# UNITED STATES PATENT AND TRADEMARK OFFICE

| APPLICATION NO.  | FILING DATE | FIRST NAMED INVENTOR | ATTORNEY DOCKET NO.          | CONFIRMATION NO. |
|--|-------------|----------------------|------------------------------|------------------|
| 10/567,068   | 02/03/2006  | Martin J. Edwards    | 14509-0138US1 /<br>P080486SE | 9468             |

### Office Action Summary

## **DETAILED ACTION**

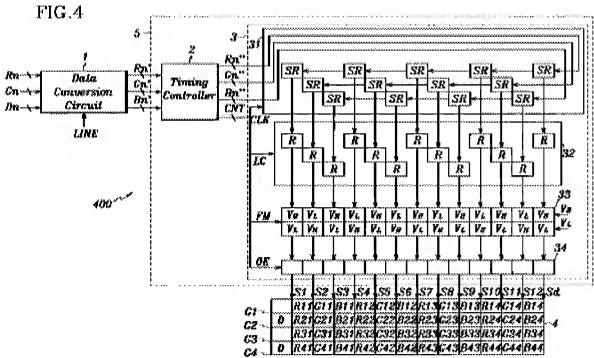
11. Examiner thanks Applicant for the well written response, however, examiner respectfully disagrees. Applicant asserts the prior art of record fails to teach "wherein the first and second capacitances of a digital to analogue conversion means comprise two column address conductors that are both associated with the same colour of picture elements." (Remarks, pg 5, 2<sup>nd</sup> ¶). A person of ordinary skill in the art, when applying the techniques of arrange color pixels as taught by Parks to the digital to analog conversion scheme of Edwards would teach the elements of the current application. Fig. 2 of the current application shows schematically part of a D/A conversion means in a know display device, as described in (pg 8, lines 4-20) WO 02/21496 / PG PUB 2002/0054005 (Examiner notes Fig 7 of Edwards 2002/0054005 does not have the color labels).

However, Parks teaches a technique to a system and method wherein picture elements in a column are of the same colour and adjacent columns of picture elements are of different colours (fig. 4 Rn", Gn" and B"), i.e. a driving means that groups common color columns. Examiner notes each column is made of a single color that alternates R, G, and B, while each color is group above to Rn", G" and B". The colors

are often grouped because of common characteristics associated with the different colors.
